HISTORIC PRESERVATION BOARD

HISTORIC PRESERVATION BOARD MEETING

PUBLIC HEARING
78 DANFORTH STREET

TO: Chair Sheridan and Members of the Historic Preservation Board
FROM: Rob Wiener, Preservation Compliance Coordinator
DATE: February 15, 2019
RE: February 20, 2019 **PUBLIC HEARING** – Site Alterations – Parking, Retaining Wall, Landscaping

DRAWING NO.
C-10

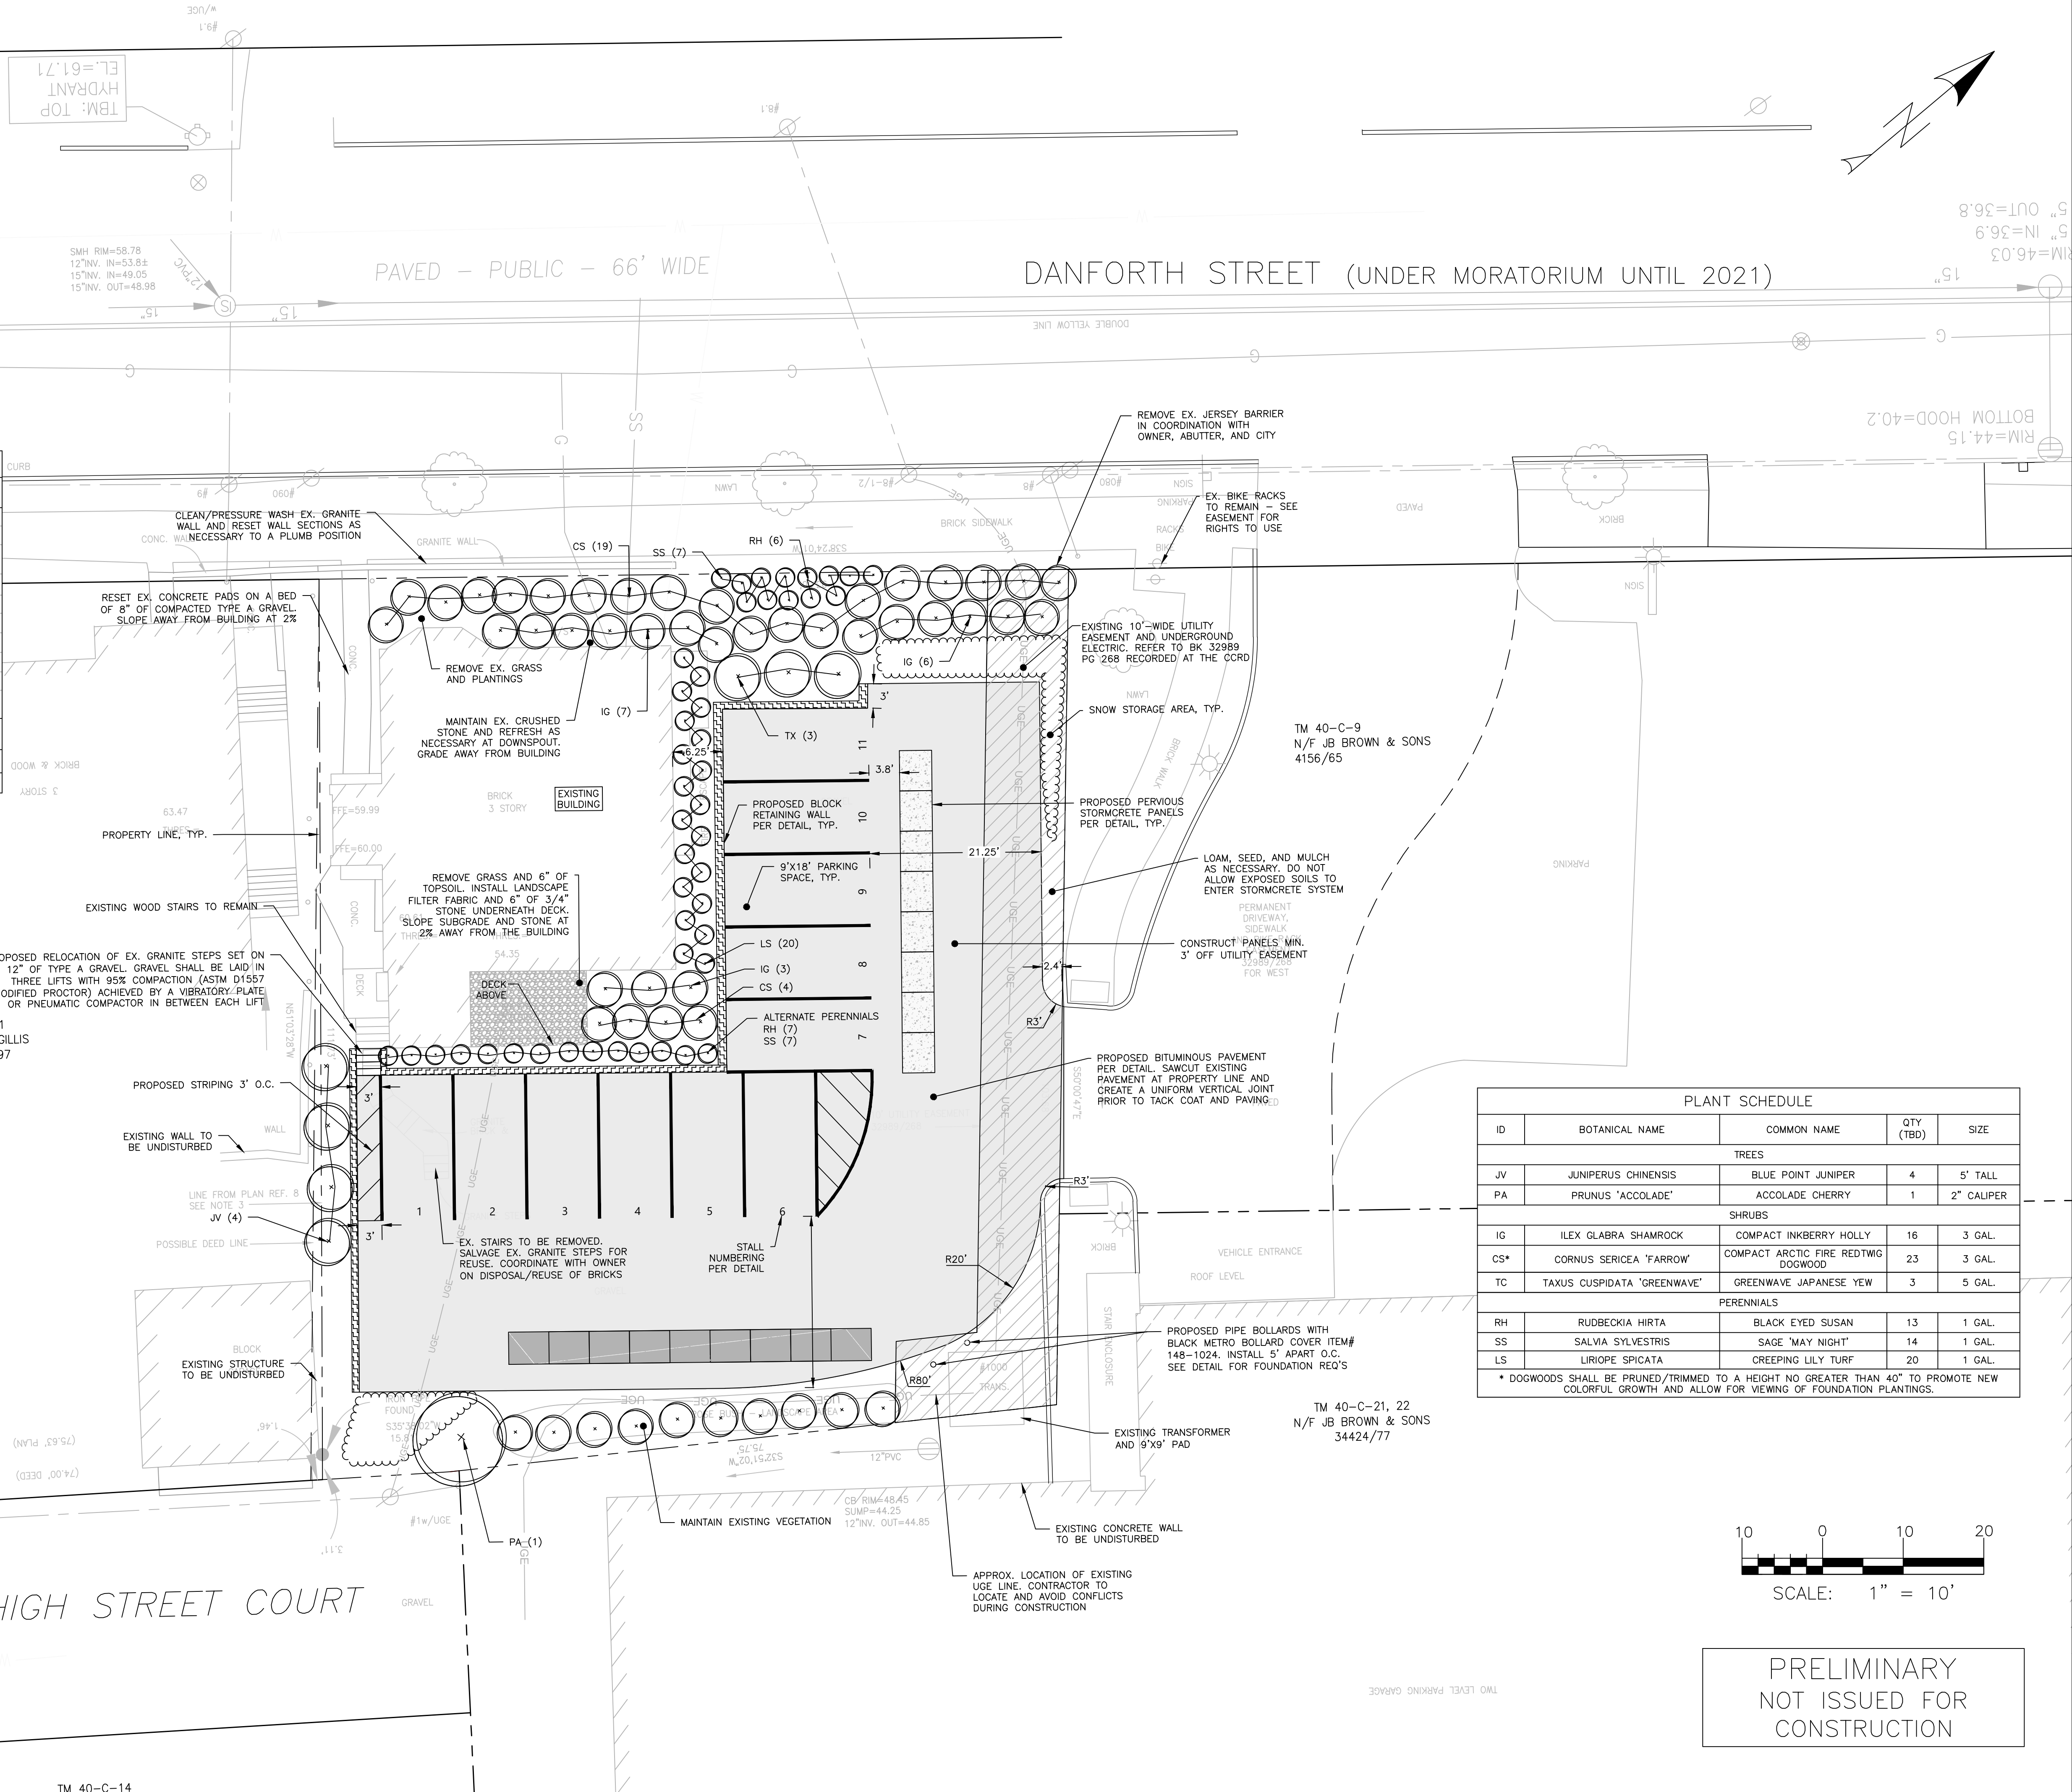
According to Acorn's analysis of applicable parking standards for historic properties in the R-6 zone (see drawing C-10, in Attachment 2,) the historic property is required to have 5 spaces. The existing number of gravel-surfaced spaces is stated as 12, far exceeding the requirement.

Staff believes perhaps a plan with nine parking spaces (reducing by two the current proposed number of eleven,) could facilitate a much softer treatment on the east side of the building. If four parking eastern spaces faced toward the street instead of the house, there could be more

landscaping at the front of the side yard, less retaining wall (further from the house,) and a more naturalized berm sloping from the front of the foundation toward the east. As of this writing staff has not discussed the idea with the consulting engineer or the owners.

There is no denying that the revised plans are an improvement over the preliminary plans by elimination of one space and added landscaping. Staff supports the proposal to improve the treatment of parking and landscaping, but has questions about the possibility for improving even more the relationship of the proposed work with the structure. It appears that only if the eastern parking spaces are oriented facing the street instead the house can the retaining wall be positioned further from the foundation.

- Removed one parking space, closest to Danforth Street
- Reduced total length of pavement by 11 feet (9' for the parking space and 2' additional feet)
- Reduced the extent of retaining wall based on above changes
- Height of wall increased by 2" where the parking changed
- Slightly adjusted the grading by the foundation to ensure that the rubble foundation will be covered up
- Added cherry tree at the rear of the site

DRAWING NO. C-10

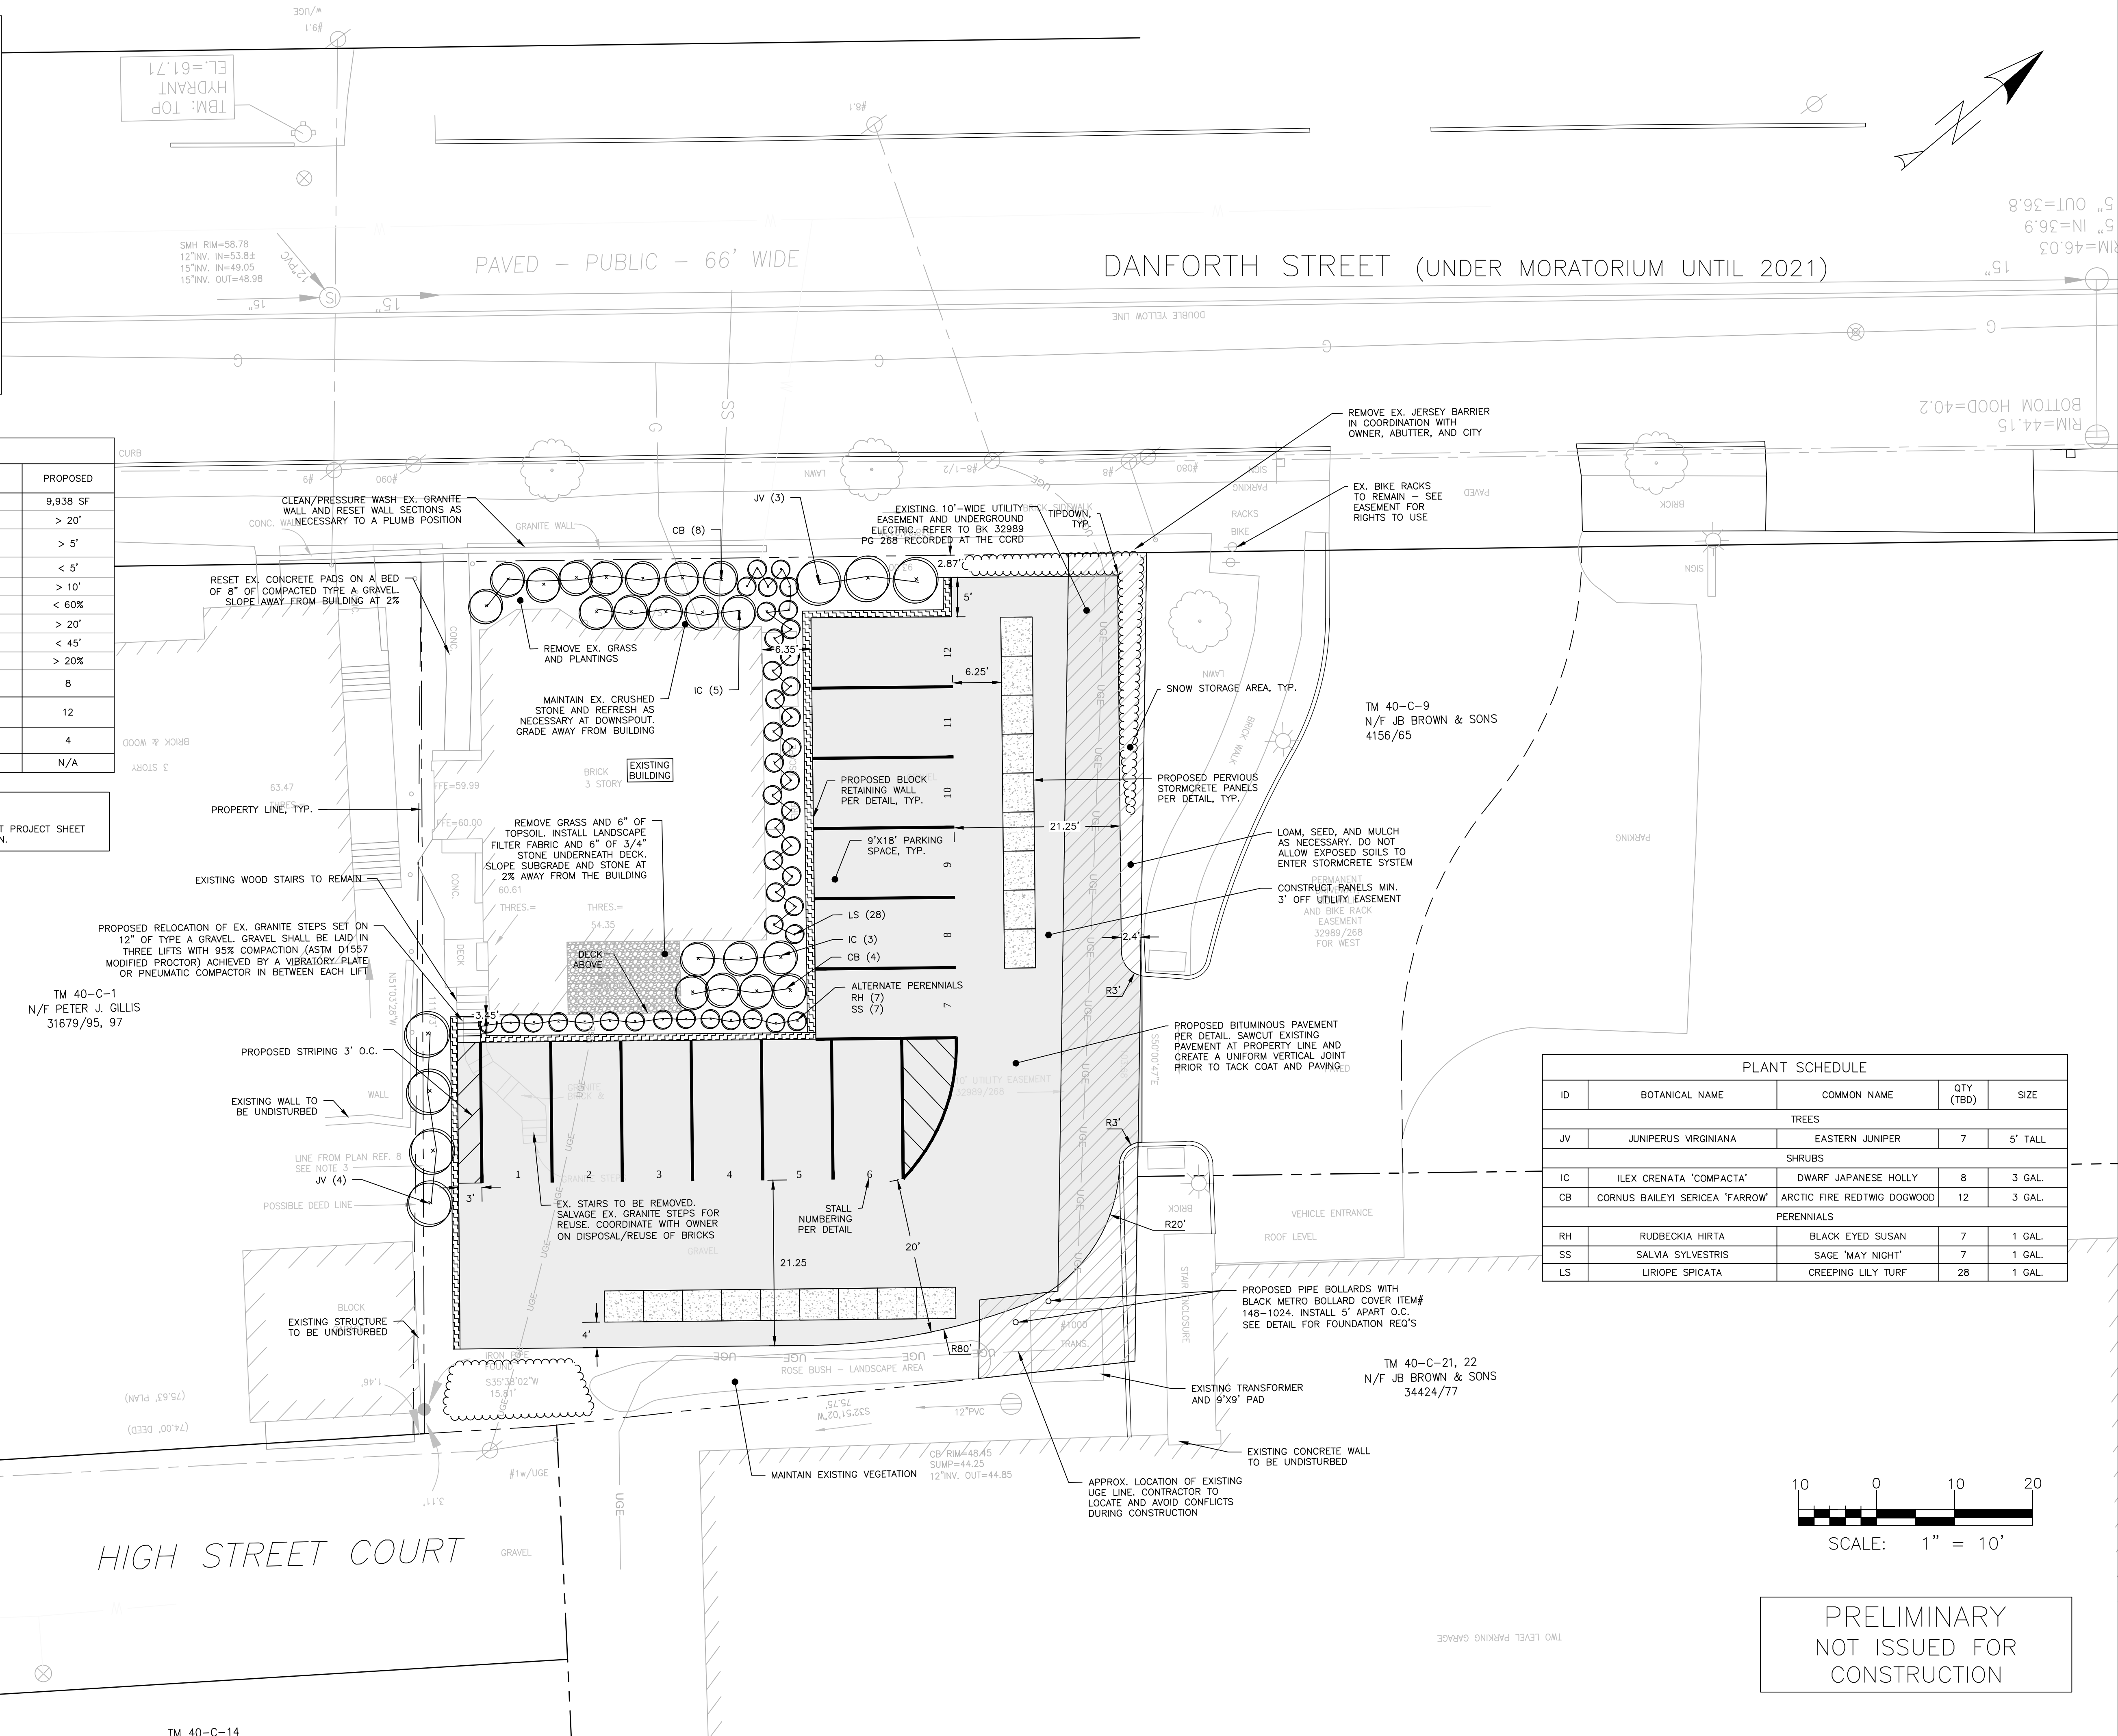
- The Board was unanimous in asking for a plan with a minimum of one fewer parking spaces.
 - The edge of one space near Danforth Street is shown on drawings as being closer to the street than the front (northeast) corner of the house. The HP Board has typically stood against parking in front yards, and zoning also prohibits parking in front setbacks in the R-6 zone. Mr. Lebel responded that he would consult the owner and property manager about a possible reduction in parking spaces.

1 SOUTH ELEVATION
SCALE: 1/4" = 1'-0"

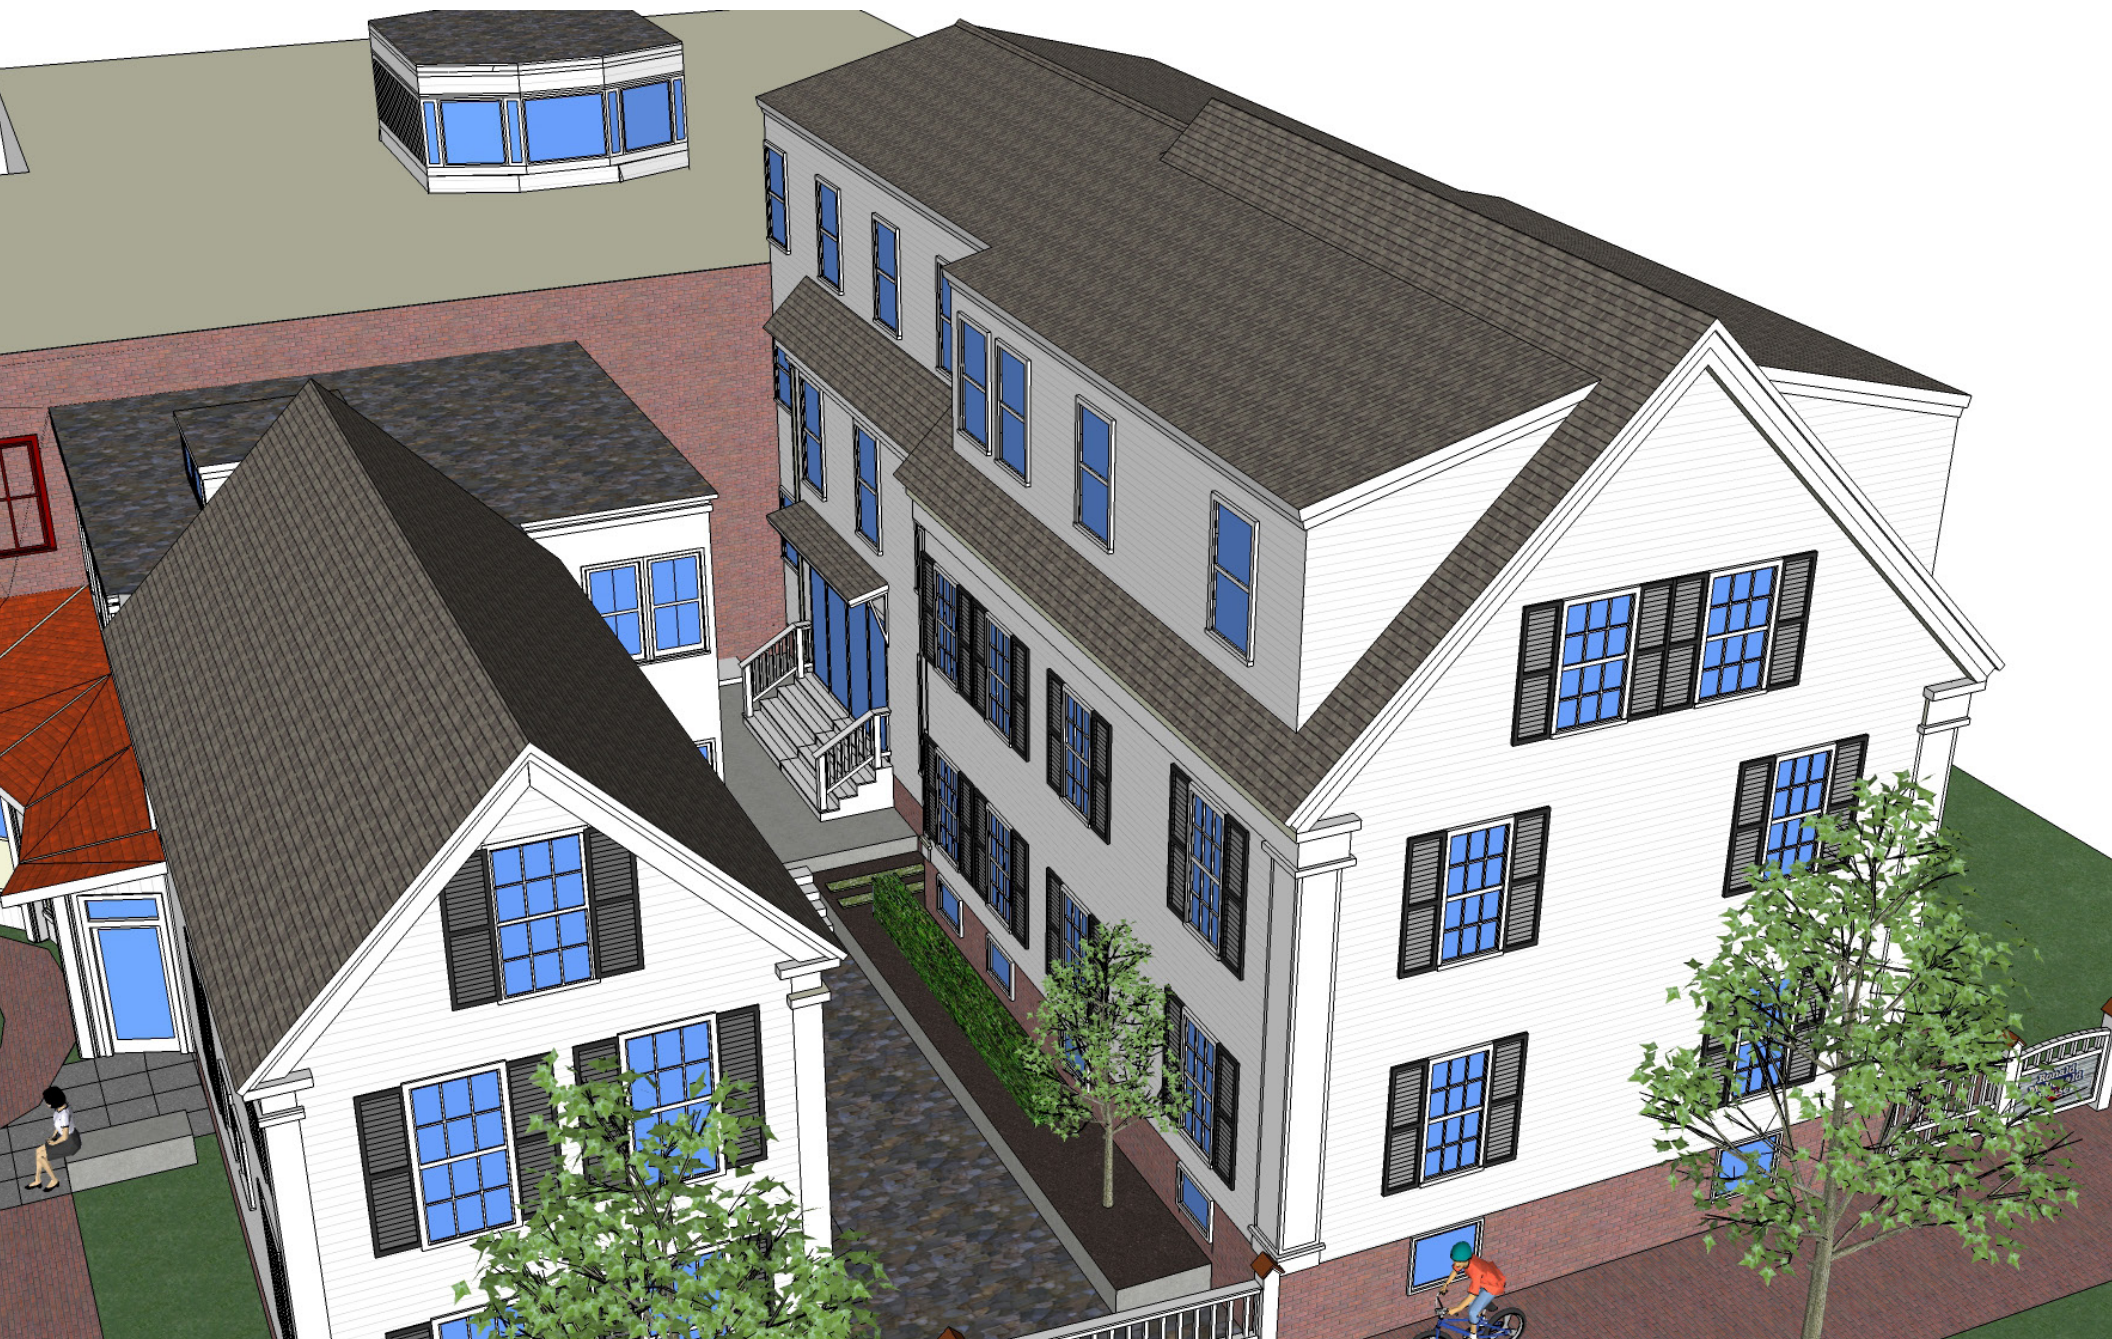
Staff is also concerned about the proposal to replace the first-floor window closest to the sidewalk on the south elevation with an egress door and transom. Given the location of the window, the fact that the south elevation is the building's primary façade and that the open parking lot next door opens up broad views of the facade, this alteration should be reconsidered and an alternative location for egress explored.

Figure 1 Pedestrian Luminaire: Previously Approved

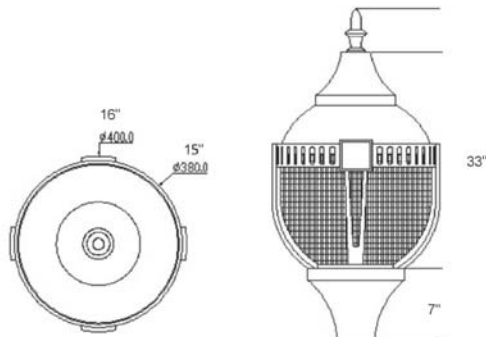
Staff request to replace the pedestrian light fixture as approved on 1.2.19 (Figure 1) with a luminaire type as represented by Option 1: Acorn (Figure 2) or Option 2: Cage (Figure 3) with the final fixture specification, manufacturer, and details to be selected by staff in conformance with the general characteristics represented in this report. If the Historic Preservation Board find the proposed light fixture to be appropriate for use within the historic landscapes as identified, the recommend pedestrian luminaire will be included in the proposed amendments to the *City of Portland Technical Manual Section 10 – Municipal Lighting Standards* as presented in this report.
